## ADDENDUM NO: 02

**DATE:** 01 April 2025  
**PROJECT NO:** 119.002  
**PROJECT:** Hyde Park Elementary School  
333 East 300 North  
Hyde Park, Utah 84318  
**OWNER:** Cache County School District  
Logan, Utah

N A Y L O R  
W E N T W O R T H  
L U N D  
A R C H I T E C T S

CU301

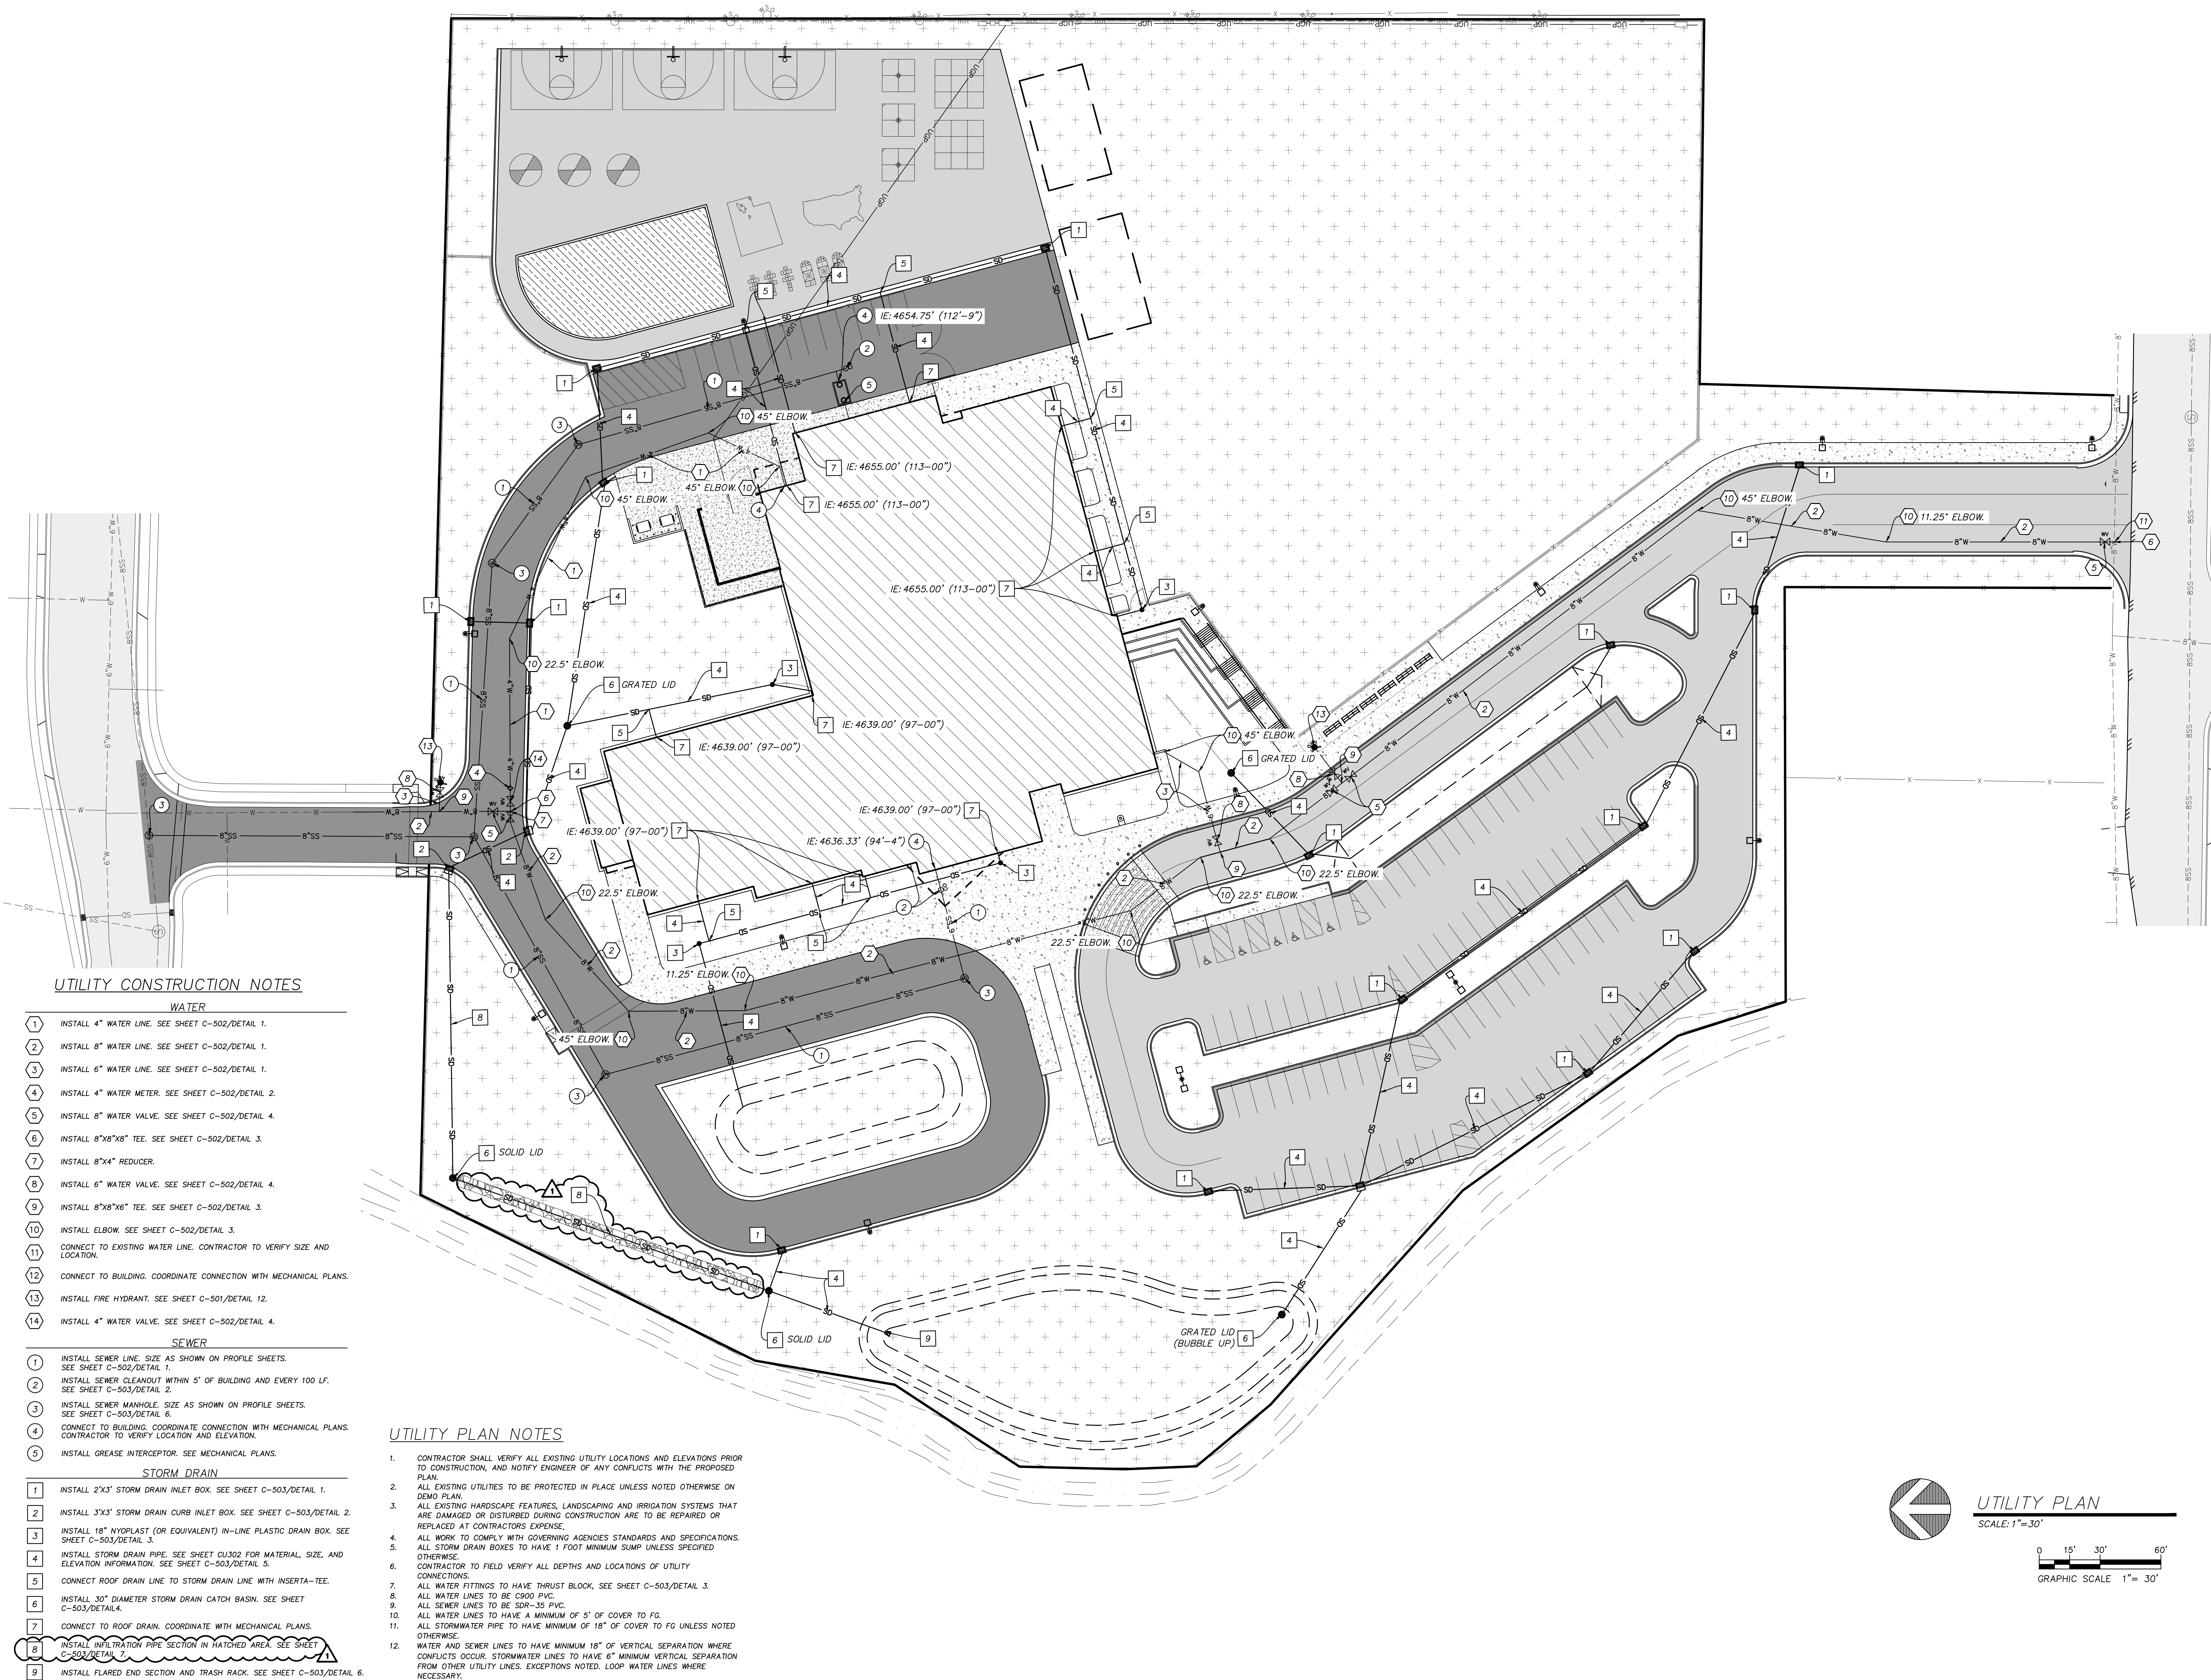
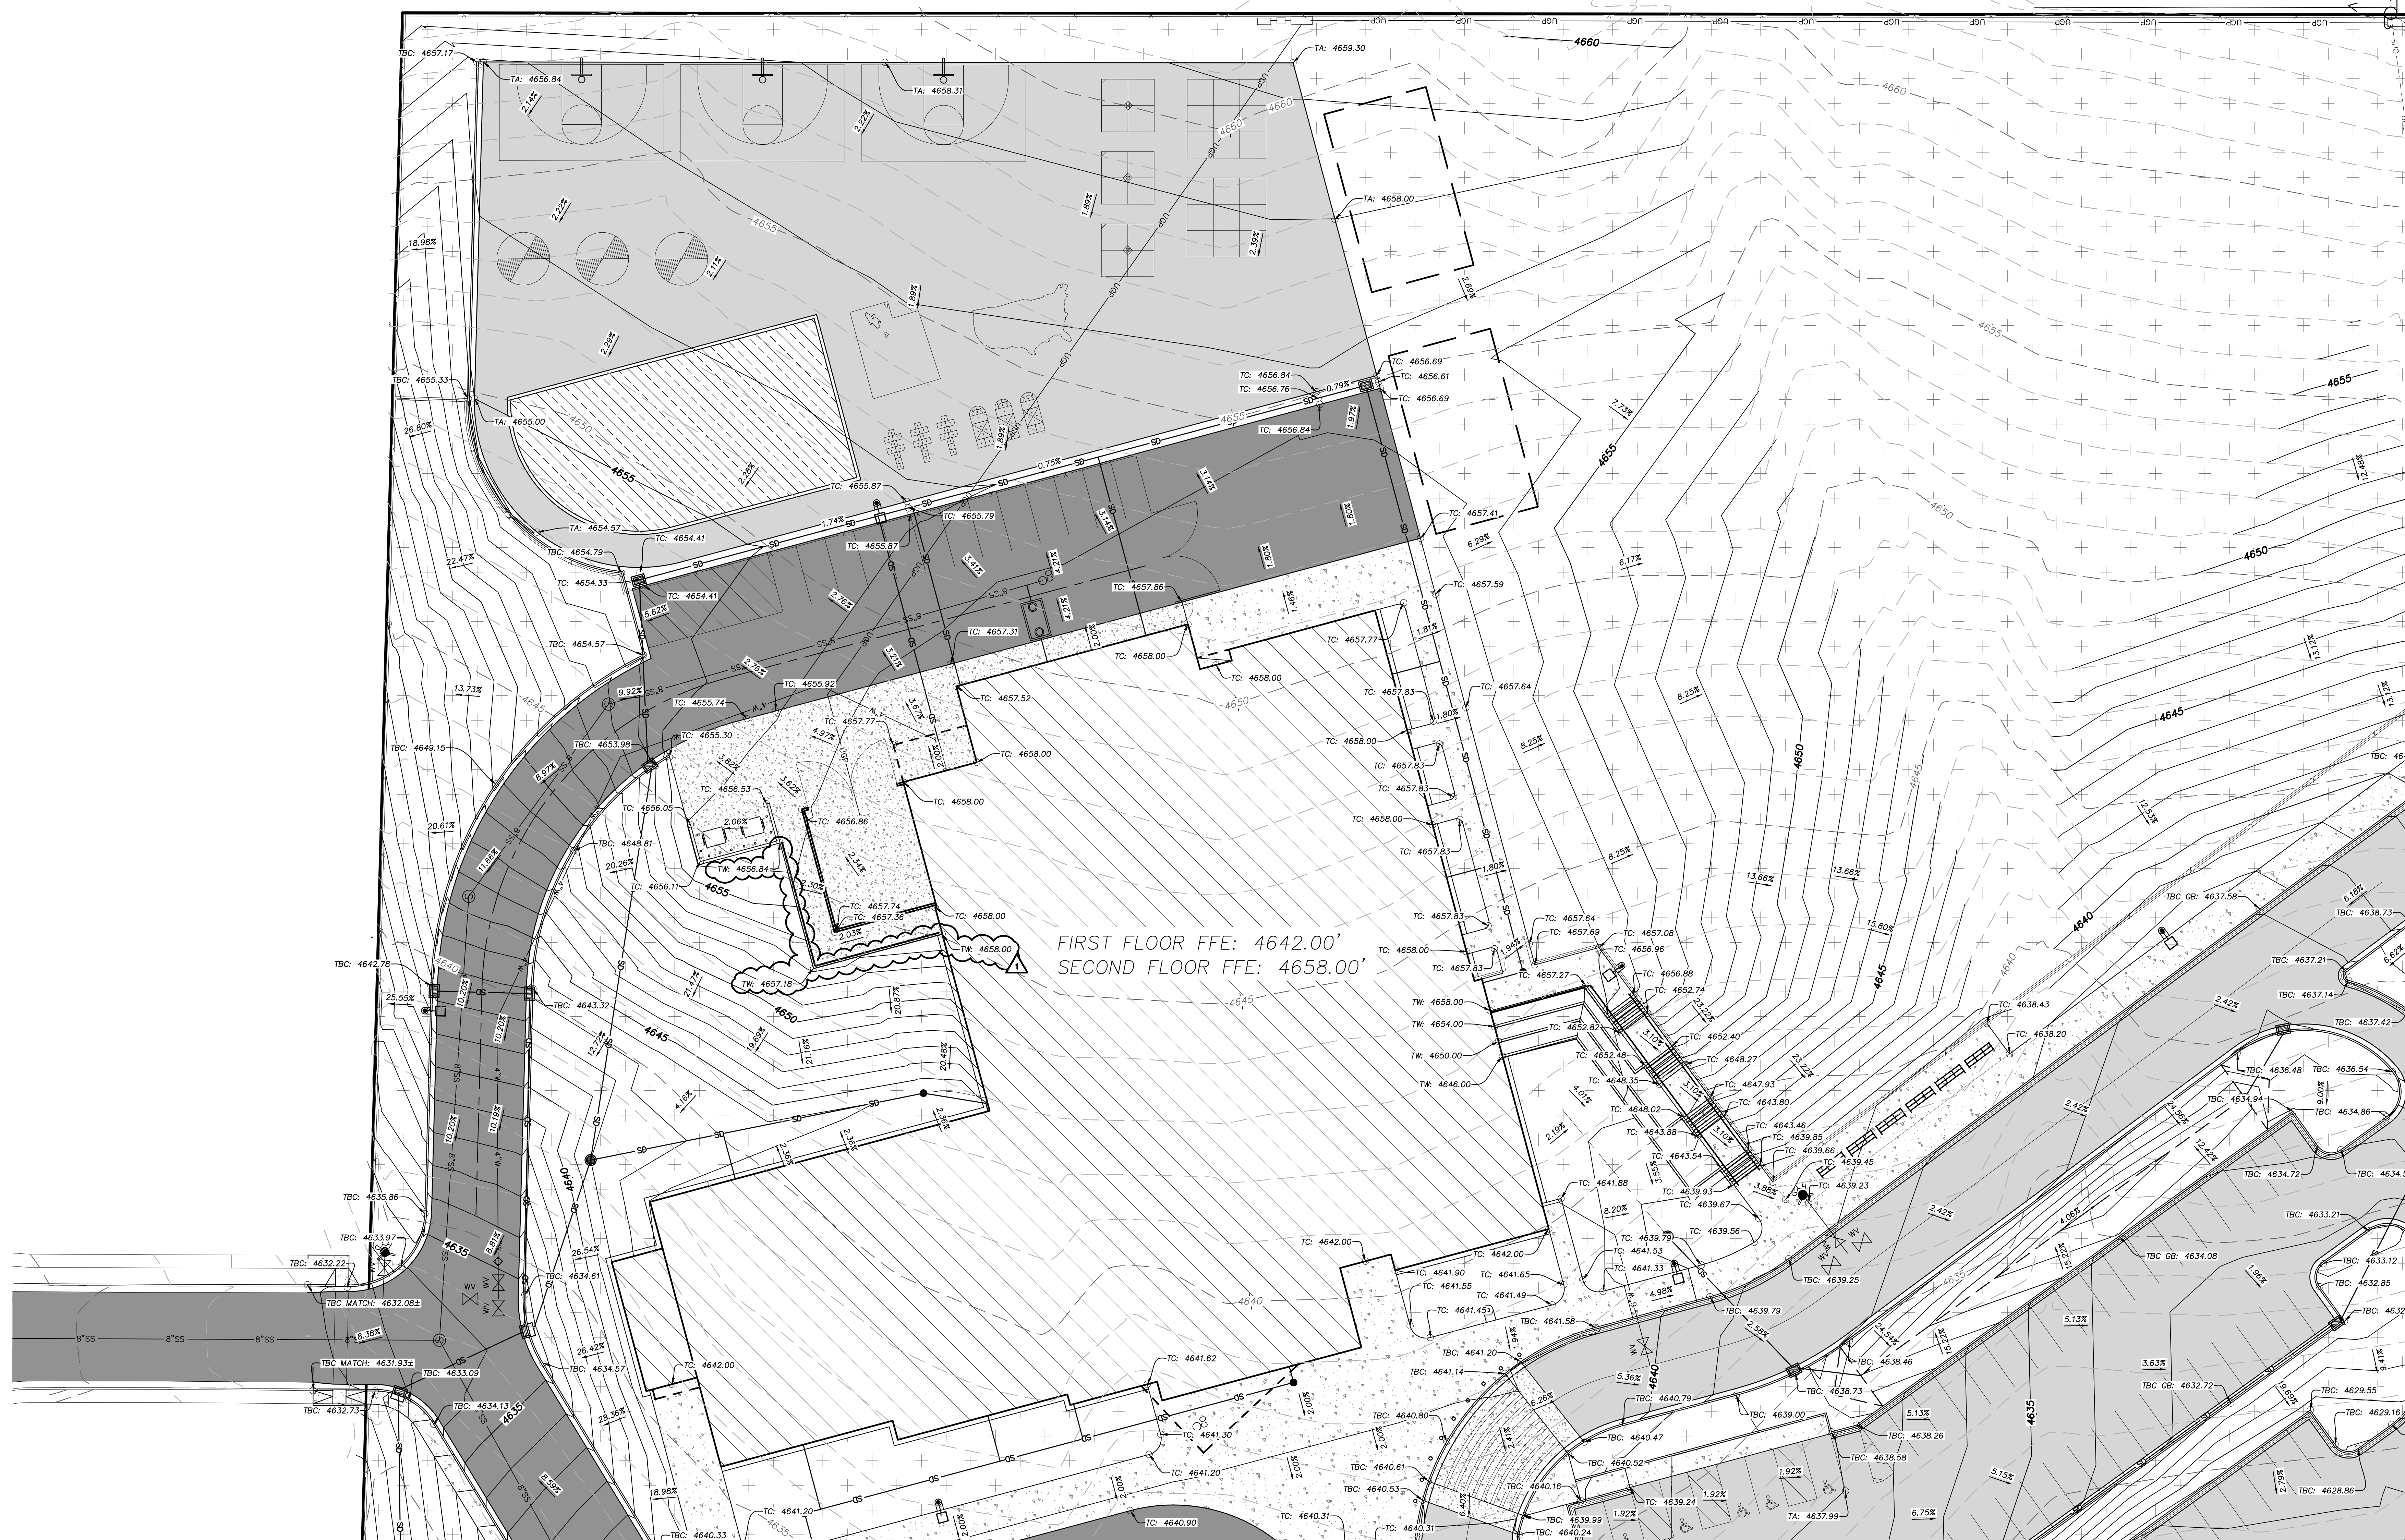
11. On sheet CU301, it is somewhat unclear where the storm drain pipe should be perforated pipe with fabric and rock. Please clarify the extent of the perforated pipe areas.

D5 AS101 PLAYGROUND STRIPING  
1" = 10'-0"

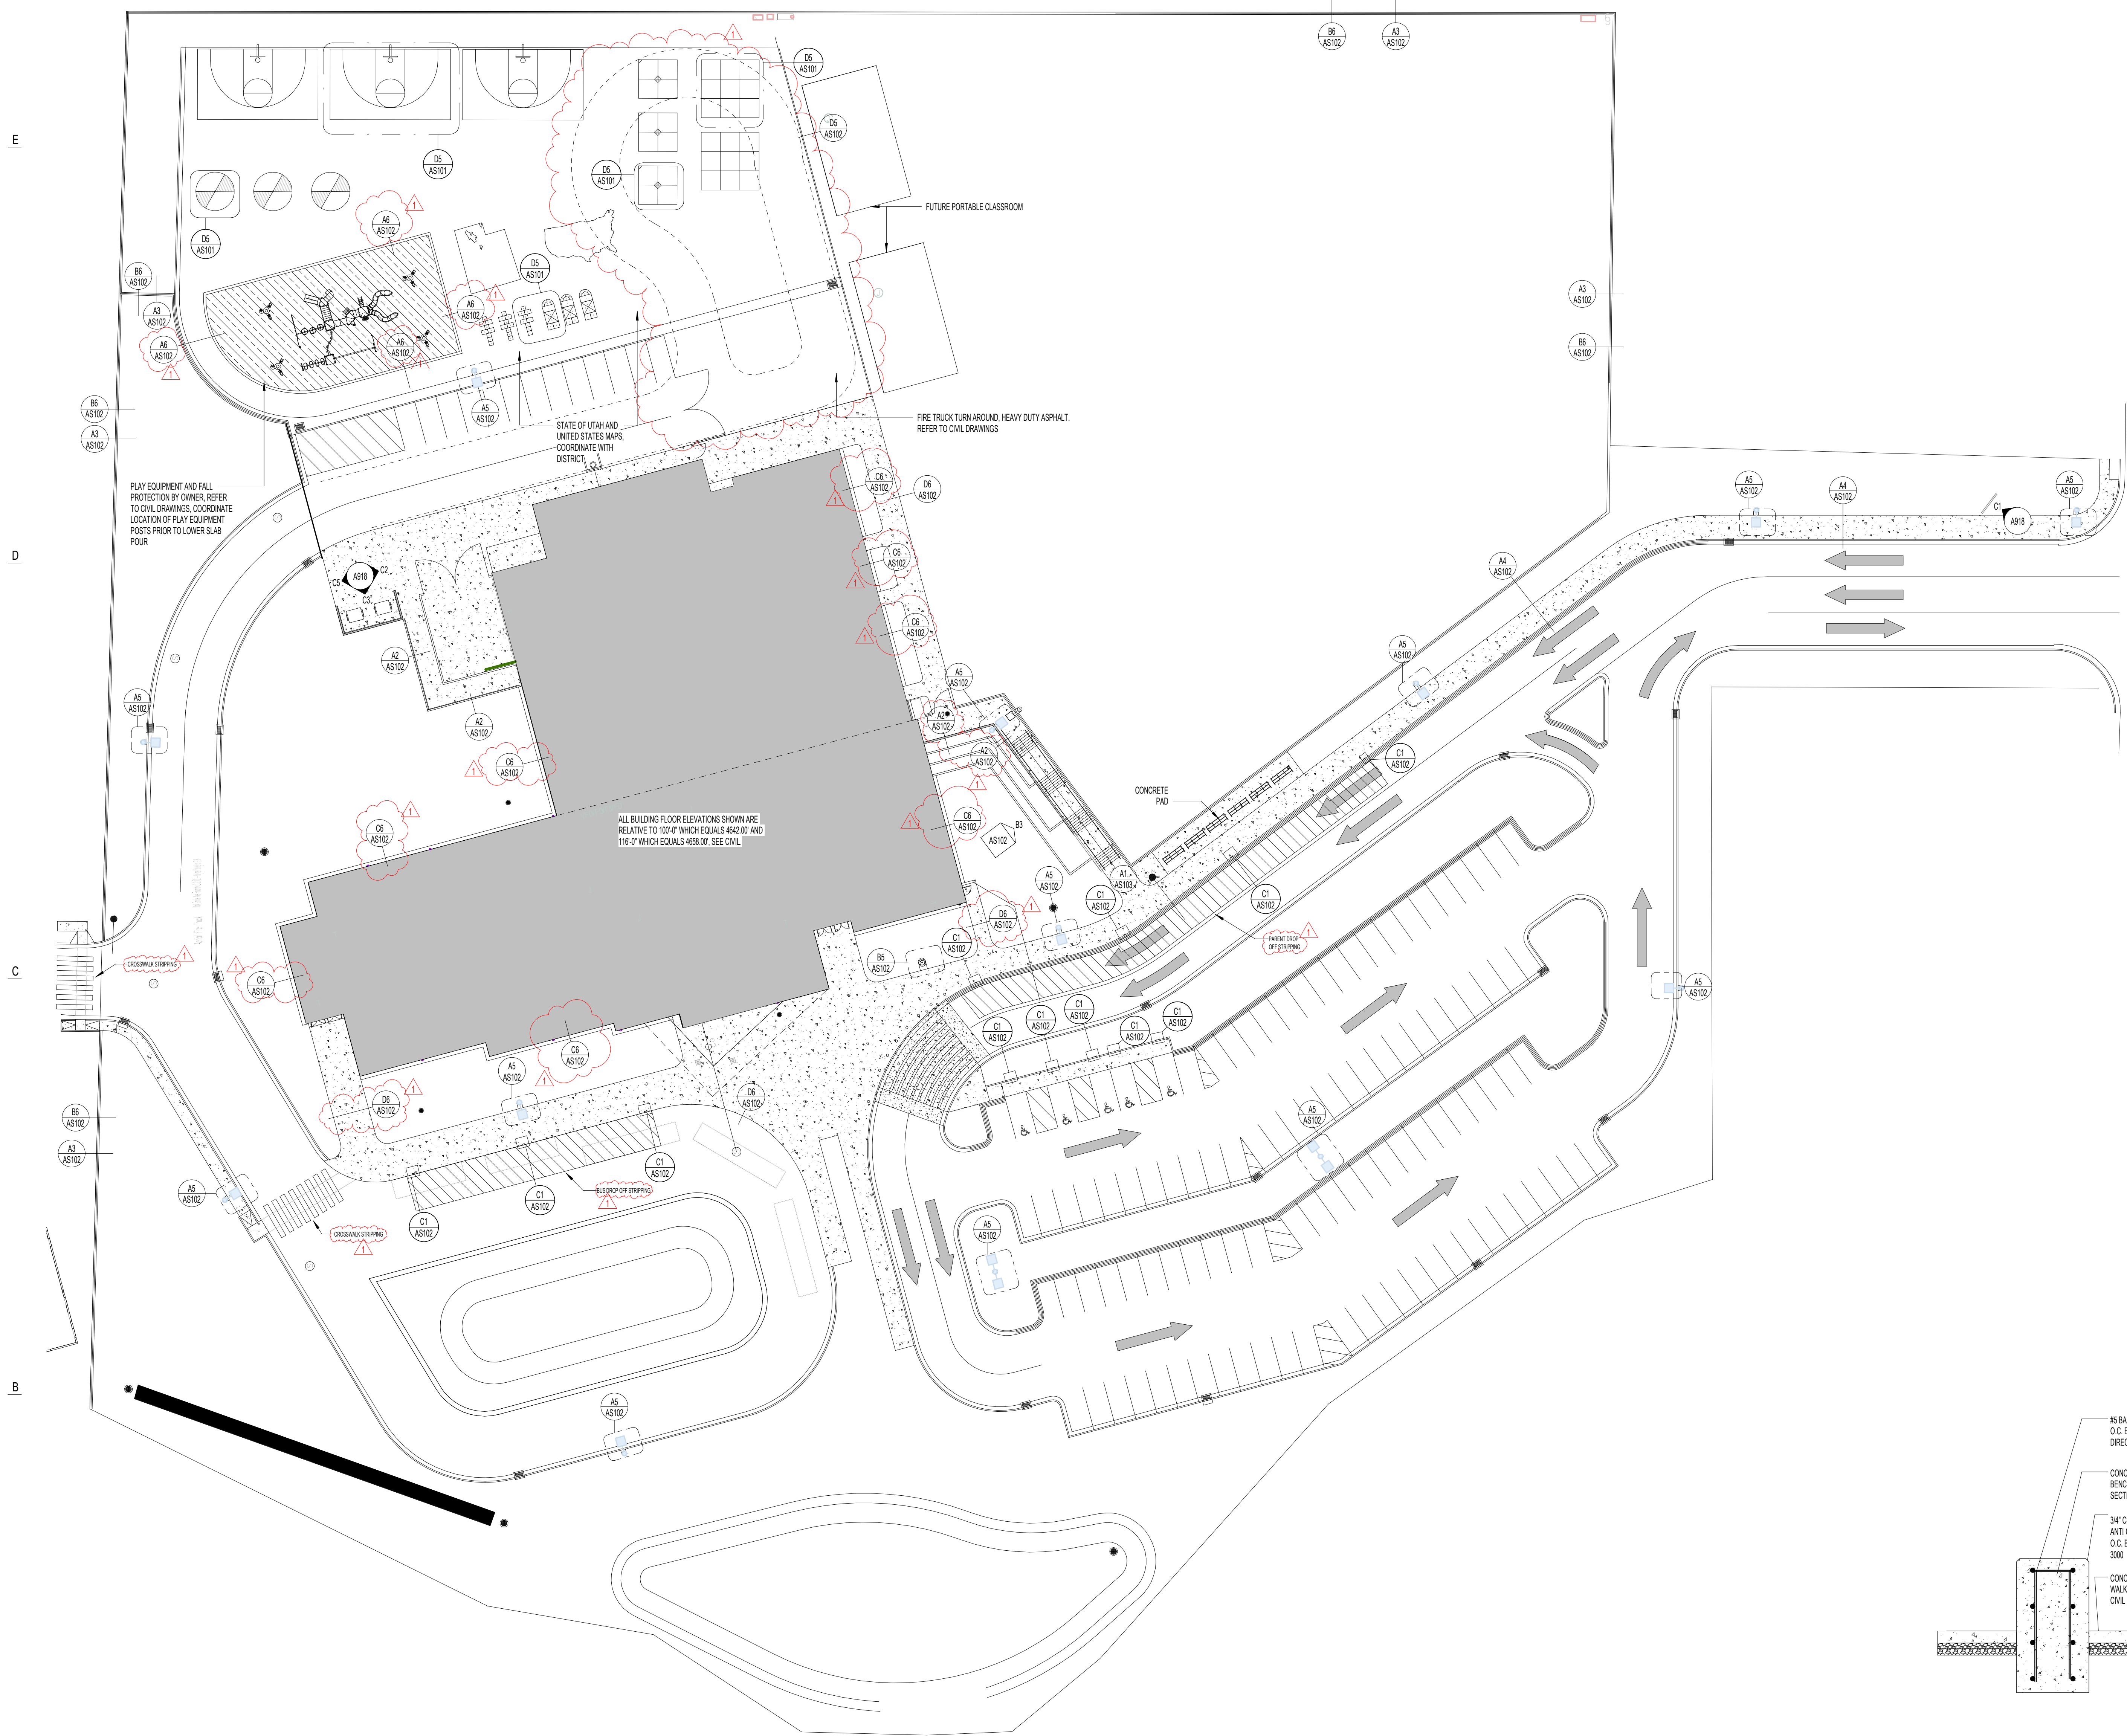
#### Sheet AS101 – ARCHITECTURAL SITE PLAN

- Detail A1/AS1020 updated to detail A6/AS102.
- Included detail A2/AS102.
- Included detail C6/AS102.
- Adjusted fire truck turn around.
- Clarified Crosswalk, Bus Dropoff and Parent Dropoff stripping.
- Detail C6/AS102 callouts added to sheet.

6. On sheet AS101, the detail for the playground curb references a detail for bollards. Please provide a detail for the playground curb.

13. Details A5 and A6/AS101 are not noted on the site plan. Please clarify where these should be constructed.
